SERVICE No. 496 BULLETIN

Piper Aircraft Corporation

Stabilator Balance Weight Tube Replacement.

PA-24-250 Comanche

Detail "A" :

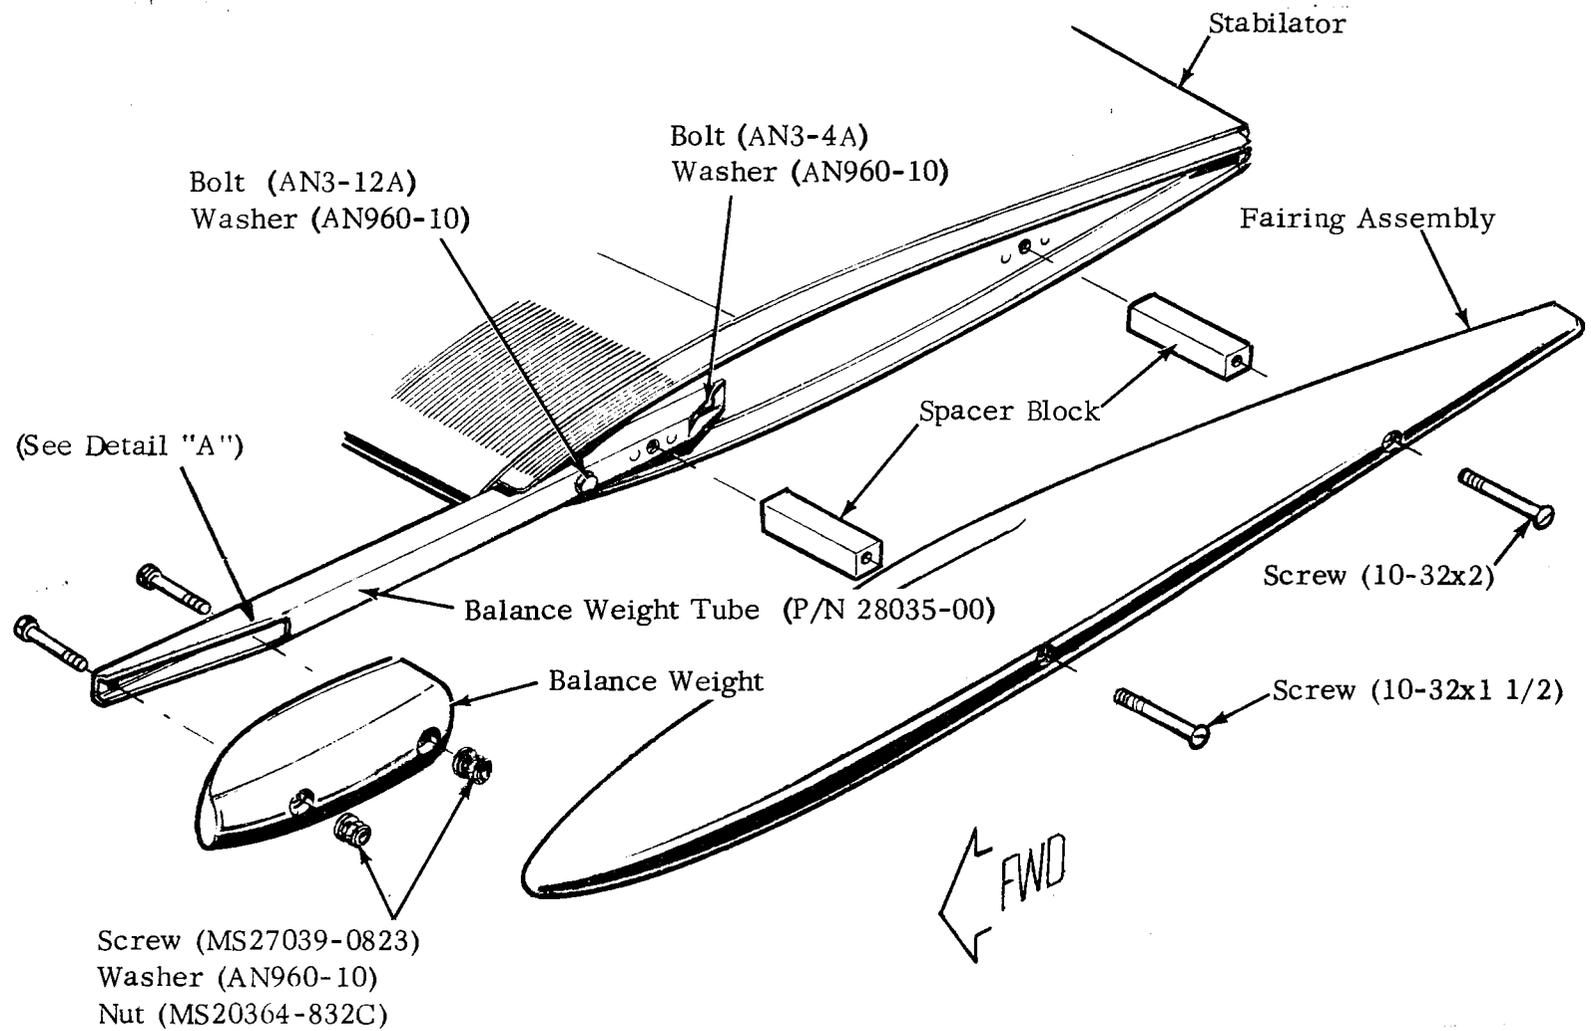
Piper Service Letter No. 687 dated June 19, 1974, announced the availability of Stabilator Modification Kit Piper Part Number 760 747 for the above referenced aircraft. Recent factory testing indicates that cracks may develop in the stabilator balance weight tube assembly (part number 28035-00, supplied with the above referenced modification kit) in the corners of the balance weight cutout.

This service release provides material to replace the stabilator balance weight tubes on aircraft that have had stabilator modification kit, Piper part number 760 747 previously installed. New stabilator balance weight tubes are provided and are redesigned with a reshaped balance weight cutout (radius cut corners) to preclude corner cracks.

Previous Tube - "squared" corners

New Tube - rounded cutout

1. Remove fairing assembly and balance weight from left and right stabilators.
2. Remove existing balance weight tubes and install new tubes P/N 28035-00.
Torque bolts to 20-25 inch pounds.
3. Reinstall balance weight and torque screws to 7-9 inch pounds.
4. Reinstall fairing assembly.
5. Make appropriate log book entry.
